UNITED STATES PATENT AND TRADEMARK OFFICE

Office Action Summary

This is the first Office Action for application number 10/801,842, Electronic Device Cradle Having Replaceable Latches, filed on 3/16/04. Claims 1-19 are pending.

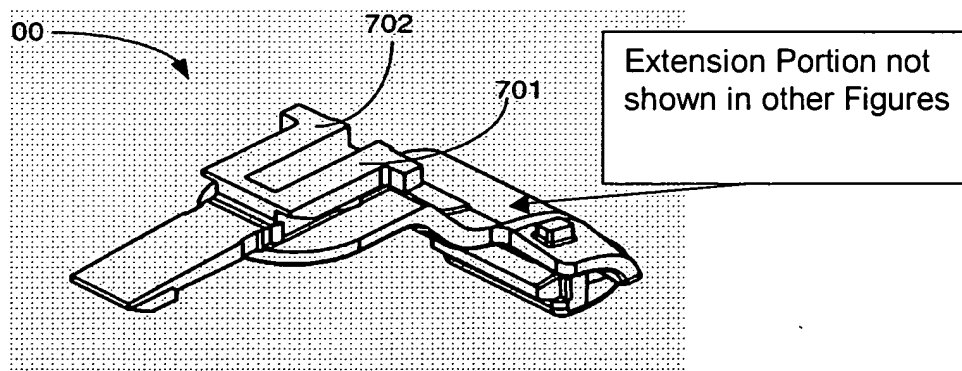
The applicant has argued that there are only two latches embodiments. This is unpersuasive in that Figure 7 does not appear to be the stabilizer of either of the recited first or second latch in that it has an extension portion (See Below) which is not shown elsewhere in the figures. Figure 7 is still considered a patentably distinct species.

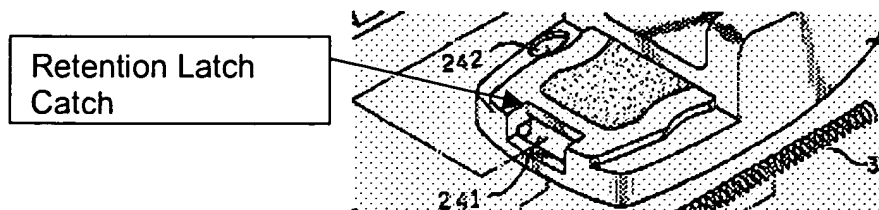
Claims 1-9 are rejected under 35 U.S.C. 102(e) as being anticipated by United States Patent No. 6816713 to Chen

The patent to Chen discloses a cradle (10, 20) and latch assembly having a body (10, 20), the body having at least one pocket (21), at least one latch aperture (241) and a latch (35) having a clasp (end of 351) and a means for coupling (353, 354, 356) to the body and a clasp arm (middle of 351) having a clasp arm length wherein the latch is detachable from the body (10, 20). Chen discloses wherein the means for coupling includes a retention latch arm (354) and a retention latch (356), wherein the retention latch arm (354) acts as a cantilever beam and wherein the latch has a thumb release (31), a stabilizing support (33) and a rear support (36) and wherein the body has a retention latch catch (the upper lip of the area surrounding the latch aperture, which catches the retention latch 356, See Drawing Below), a rear support recess (11), a latch guide (246) and a rotation support (22, 23).
